ACCESSIBILITY CHECKLIST

DEPARTMENT OF REHABILITION

4930 W KAWEAH COURT SUITE 100 VISALIA, CA 93277

RESD PROJECT #139602

OPEN PARKING FRONT (PK1)

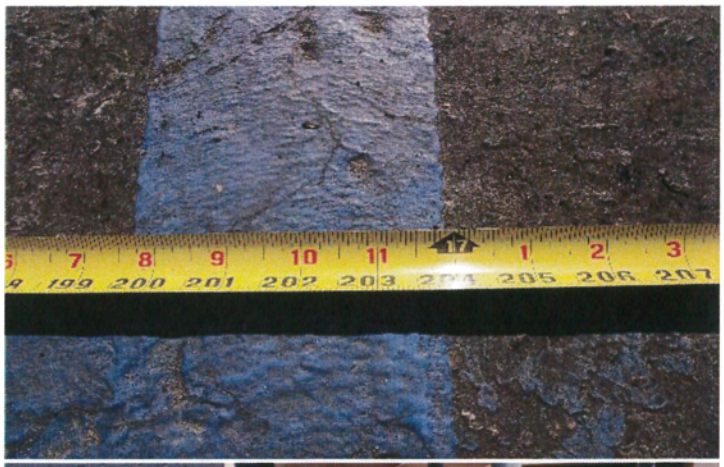
1.2	Number - Accessible Parking Spaces	Where parking spaces are provided for self-parking by employees or visitors or both, is the required number of accessible parking spaces provided? (See Minimum Requirements Summary Sheet A) (Note: All or some of the accessible parking spaces may be in a different location if equivalent or greater accessibility is ensured.) 11B-208.2, Table 11B-208.2	± 37 SPACES 2 ACCESSIBLE SPACES REQ. 1 PROVIDED		Yes ☐ No ■ N/A ☐

CURB RAMP SERVING THE OPEN PARKING REAR (PK2)

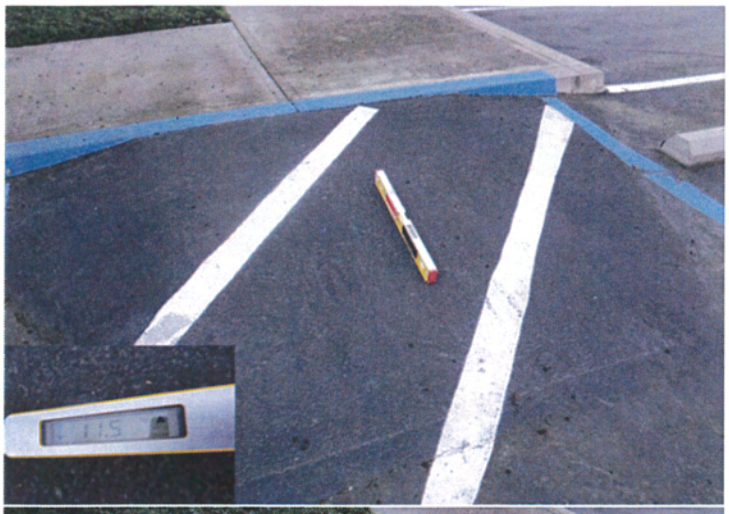
4.9	Detectable Warning	Does the curb ramp have detectable warning? 11B-406.5.12, 11B-705.1			Yes □ No ■ N/A □
4.10	Detectable Warning	Does the detectable warning consist of raised truncated domes, which contrast visually with adjoining surfaces (light-on-dark or dark-on-light), and is the material used to provide contrast an integral part of the walking surface? 11B-705.1.1.3			Yes □ No ■ N/A ■

(ER3) ROUTE OF TRAVEL BETWEEN THE REAR ACCESSIBLE PARKING (PK2) & THE MAIN (WEST) BUILDING ENTRANCE

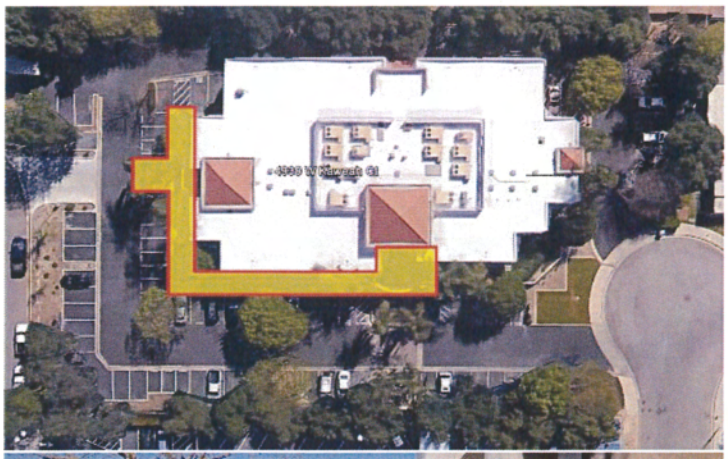
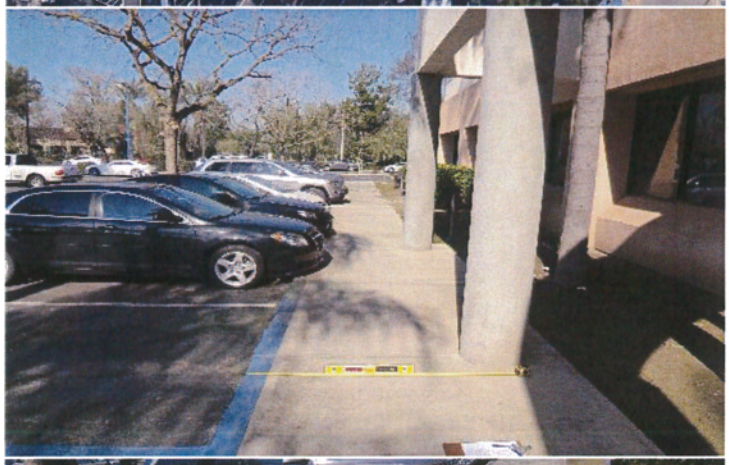
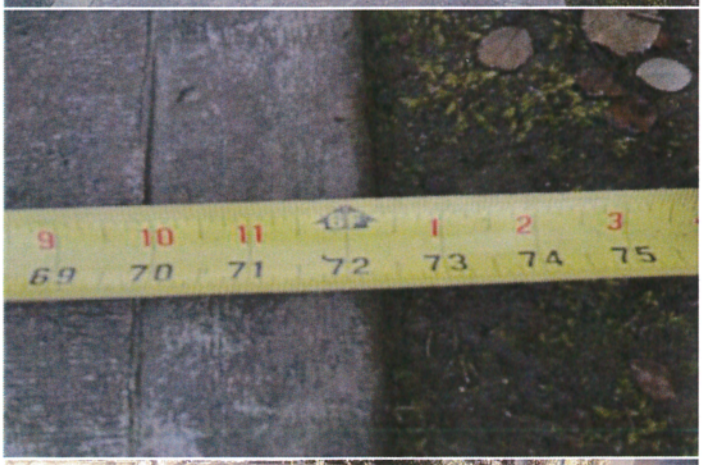
3.12B	Changes in Level	When walkway levels change, is the vertical distance between them less than 1/4 inch? **OR** Are changes in level between 1/4 inch and 1/2 inch beveled with a slope no greater than 1:2? 11B-303.2, 11B-303.3			Yes ☐ No ■ N/A ☐

- PARKED VEHICLES ARE ALLOTTED ±36" OF OVERHANG OF WALKWAYS - IT REQUIRES A MINIMUM 7' WIDE WALKWAY TO MAINTAIN MINIMUM 48" WIDE WALKWAYS/ ACCESSIBLE ROUTES OF TRAVEL - WHEEL STOPS MAY BE USED TO LIMIT THE OVERHANG DEPTH OF PARKED VEHICLES.

(ER4) ROUTE OF TRAVEL BETWEEN THE REAR ACCESSIBLE PARKING (PK2) & THE REAR (EAST) BUILDING ENTRANCE

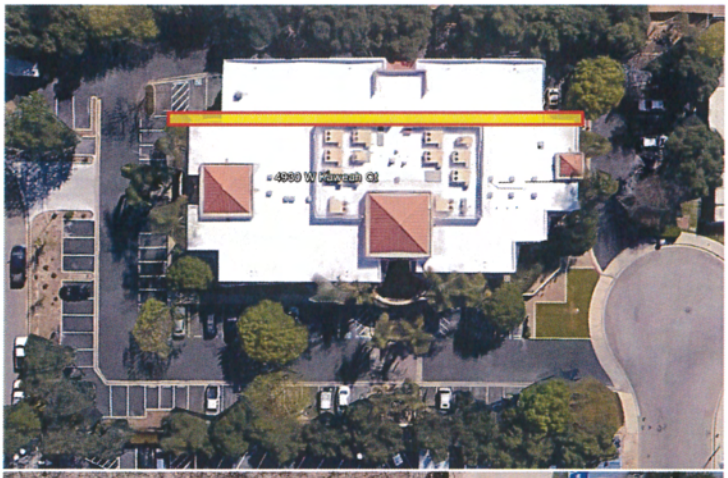
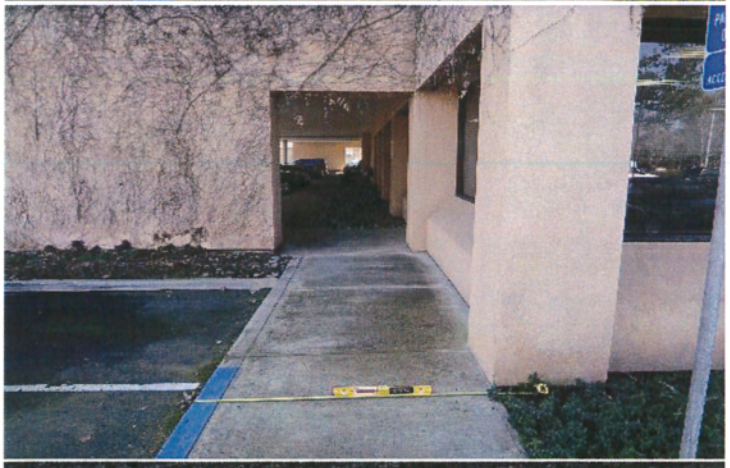
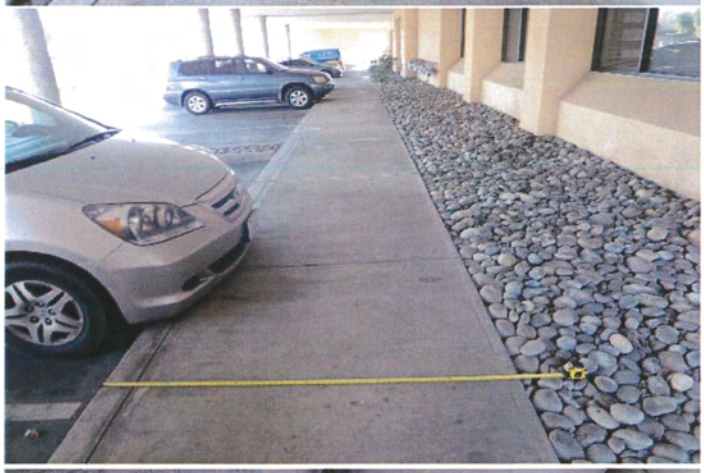
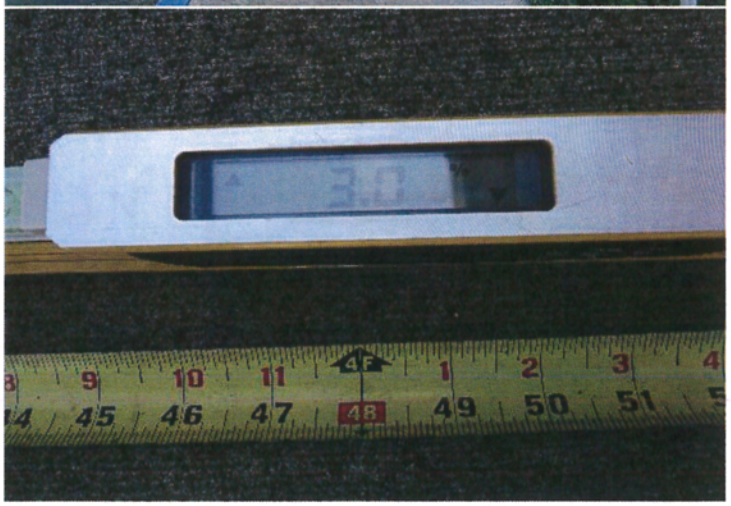
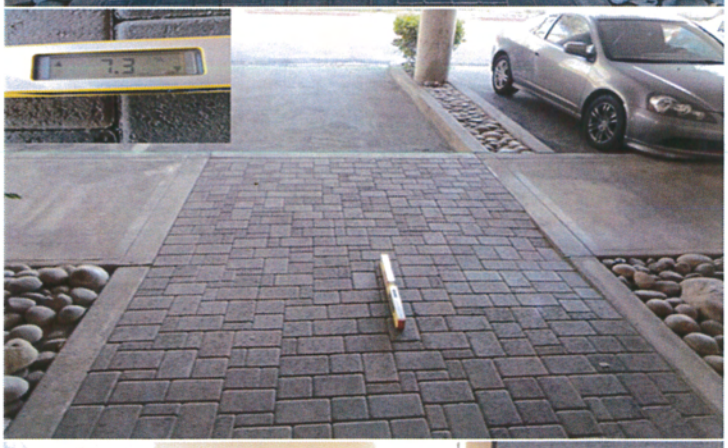
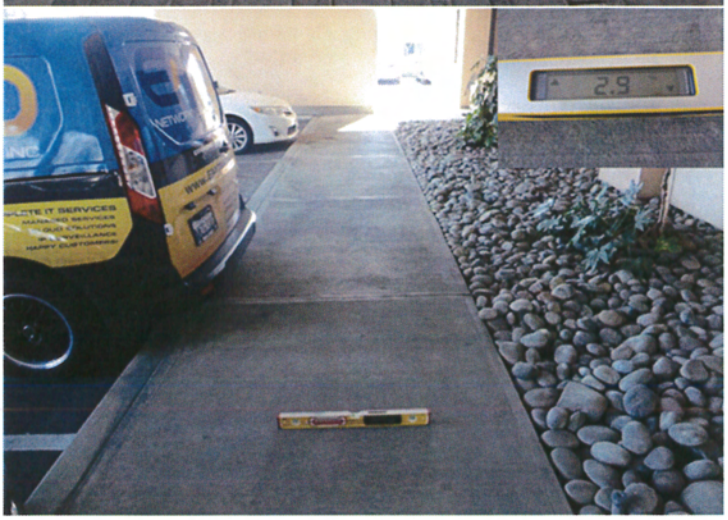
4.9	Detectable Warning	Does the curb ramp have detectable warning? 11B-406.5.12, 11B-705.1			Yes ☐ No ■ N/A ☐
4.10	Detectable Warning	Does the detectable warning consist of raised truncated domes, which contrast visually with adjoining surfaces (light-on-dark or dark-on-light), and is the material used to provide contrast an integral part of the walking surface? 11B-705.1.1.3			Yes ☐ No ☐ N/A ■

- PARKED VEHICLES ARE ALLOTTED ±36" OF OVERHANG OF WALKWAYS - IT REQUIRES A MINIMUM 7' WIDE WALKWAY TO MAINTAIN MINIMUM 48" WIDE WALKWAYS/ ACCESSIBLE ROUTES OF TRAVEL - WHEEL STOPS MAY BE USED TO LIMIT THE OVERHANG DEPTH OF PARKED VEHICLES.

(ER5) ROUTE OF TRAVEL BETWEEN THE MAIN (WEST) ENTRANCE WALKWAY & THE EXTERIOR (WEST) PATIO AREA

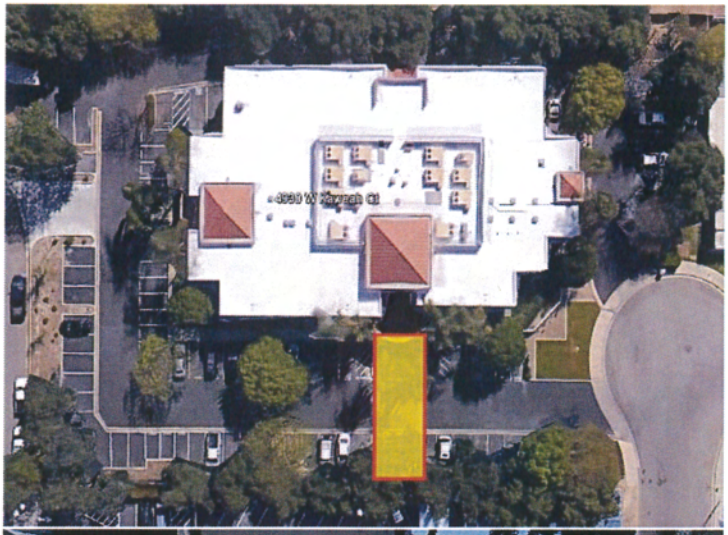
3.12B	Changes in Level	When walkway levels change, is the vertical distance between them less than 1/4 inch? **OR** Are changes in level between 1/4 inch and 1/2 inch beveled with a slope no greater than 1:2? 11B-303.2, 11B-303.3	NOT @ DRIVE AISLE/ VALLEY GUTTER TRANSITION		Yes ☐ No ■ N/A ☐

(EN1) MAIN (WEST) ENTRANCE

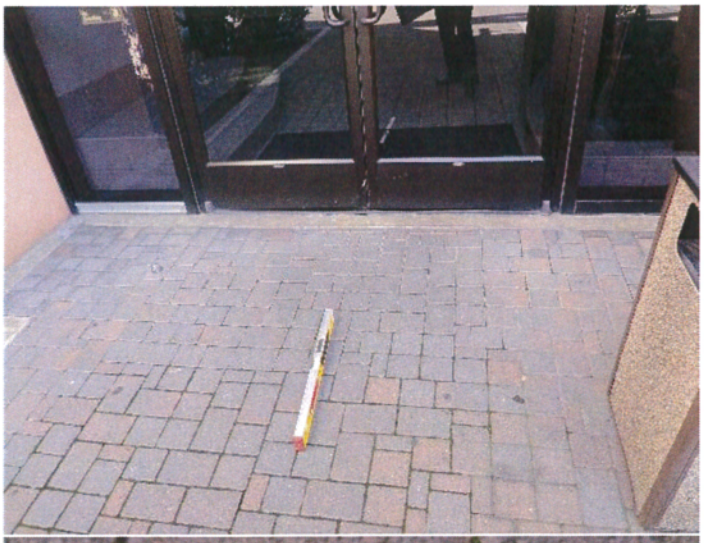
10.12	Other Door Requirements	Does the entrance door comply with all applicable requirements of Survey Form 11 - Doors and Gates? If not, check the "No" field and enter all non-complying item numbers in the comment field (to the right of this box). This will eliminate the need to fill out Form 11 for this entrance. 11B-206.4	11.7 11.13 11.16 11.20		Yes ☐ No ■ N/A ☐

10.17	Other	If you have identified any other related barriers that were not covered by this survey form, check the "No" field and provide that information below.	UNSECURED FLOOR MAT @ INTERIOR		Yes ☐ No ■ N/A ☐

(EN3) SOUTH EMPLOYEE USE ENTRANCE/EXIT & SOUTH EXIT EXTERIOR STAIRS

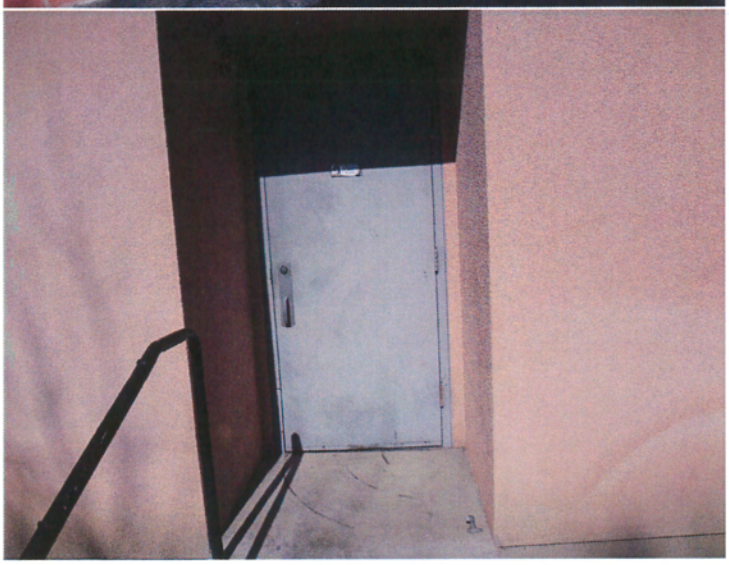
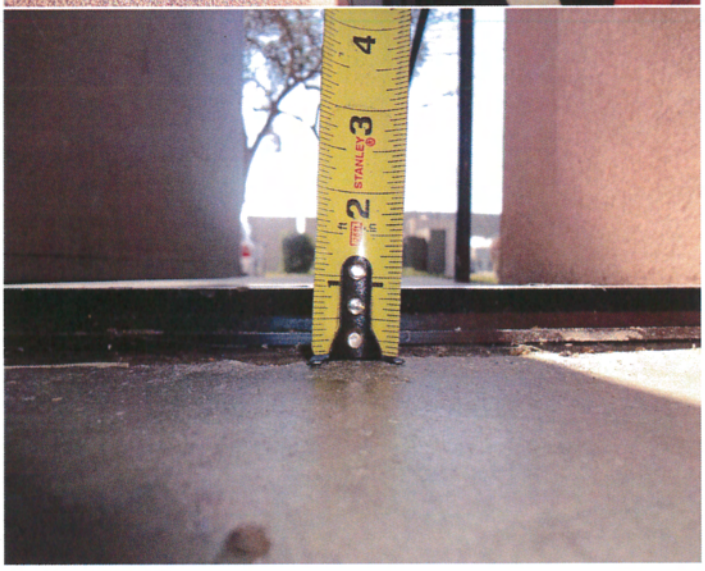
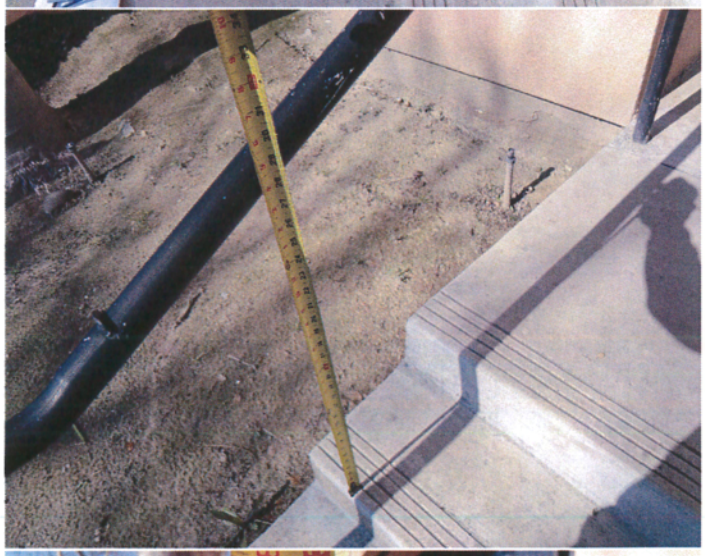
10.6	Door Maneuvering Space	If the door is not automatic or power assisted, does it have maneuvering space relative to the direction of approach as shown in CBC Table 11B-11B-404.2.4.1? *Approach* / *Side* / *Perpendicular to Door* / *Parallel to Door (beyond latch side unless noted)* Front / Pull / 60" / 18"***** Front / Push / 48" / 0"* Hinge / Pull / 60" / 36" Hinge / Push / 44"** / 22"*** Latch / Pull / 60"**** / 24" Latch / Push / 44"**** / 24" * Add 12" if closer and latch are provided. ** Add 4" if closer and latch are provided. *** Beyond hinge side. **** Add 4" if closer is provided. ***** Add 6" at exterior side of exterior doors. 11B-404.2.4 Fig. 11B-404.2.4.1	PULL SIDE LATCH <24" PUSH SIDE <48"&44"		Yes ☐ No ■ N/A ☐

10.12	Other Door Requirements	Does the entrance door comply with all applicable requirements of Survey Form 11 - Doors and Gates? If not, check the "No" field and enter all non-complying item numbers in the comment field (to the right of this box). This will eliminate the need to fill out Form 11 for this entrance. 11B-206.4	11.6 11.10 11.13 11.14 11.21		Yes ☐ No ■ N/A ☐

10.17	Other	If you have identified any other related barriers that were not covered by this survey form, check the "No" field and provide that information below.	ENTRANCE/EXIT STAIRS - SEE FOLLOWING SHEETS		Yes ☐ No ■ N/A ☐

(EN4) DEPARTMENT OF REHABILITATION SUITE 100
PUBLIC ENTRANCE

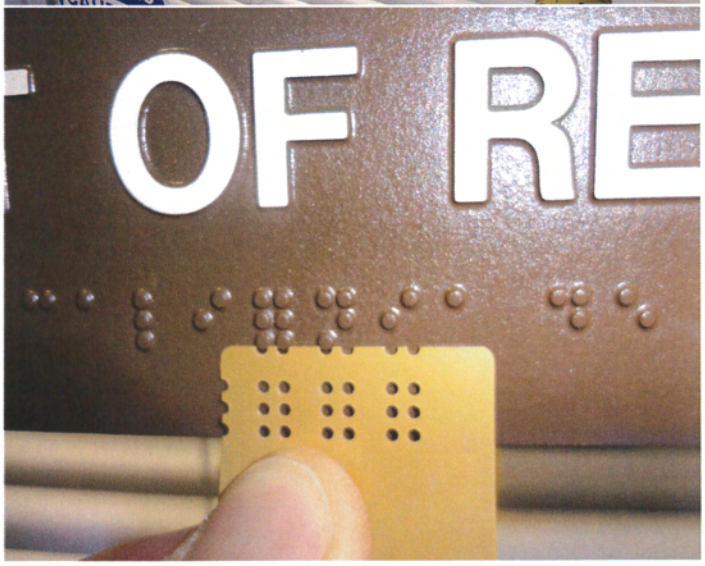
10.12	Other Door Requirements	Does the entrance door comply with all applicable requirements of Survey Form 11 - Doors and Gates? If not, check the "No" field and enter all non-complying item numbers in the comment field (to the right of this box). This will eliminate the need to fill out Form 11 for this entrance. 11B-206.4	11.18 11.19 11.23 11.27		Yes ☐ No ■ N/A ☐

(IR1) BUILDING LOBBY

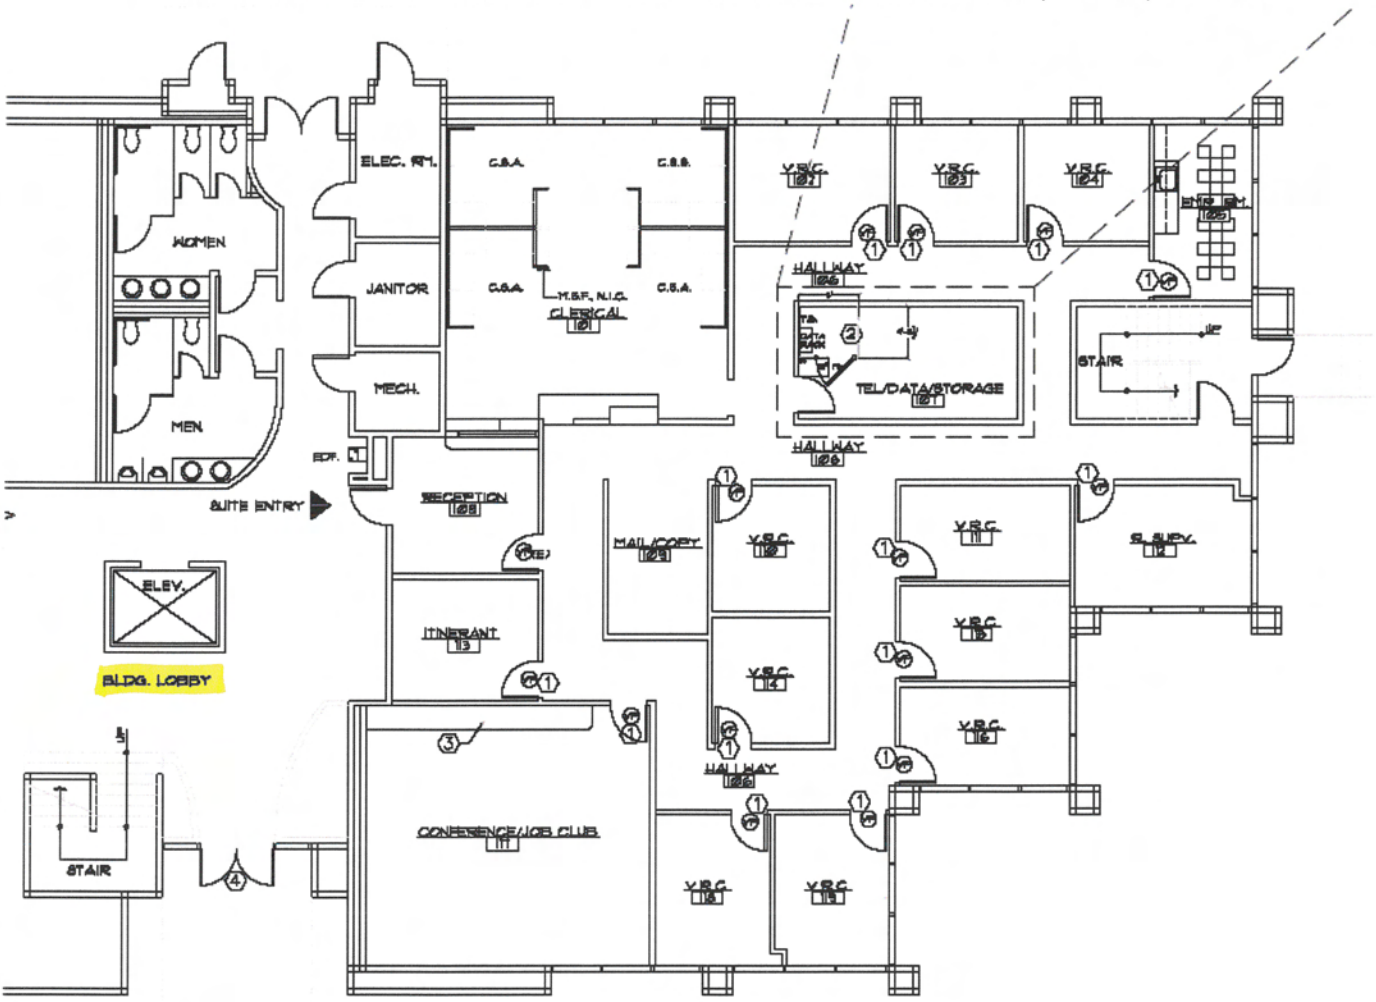
12.11A	Directional and Informational Signs	Do signs which provide direction to, or information about, functional spaces of the building interior and exterior comply with the requirement for visual signage? EXCEPTION: Building directories, menus, and all other signs which are temporary are not required to comply. 11B-216.3, 11B.703.5	JANITOR & ELEVATOR EQUIPMENT		Yes ☐ No ■ N/A ☐

12.30A	Other	If you have identified any other related barriers that were not covered by this survey form, check the "No" field and provide that information below.	OPERABLE PART OF FIRE EXTINGUISHER — >48"		Yes ☐ No ■ N/A ☐
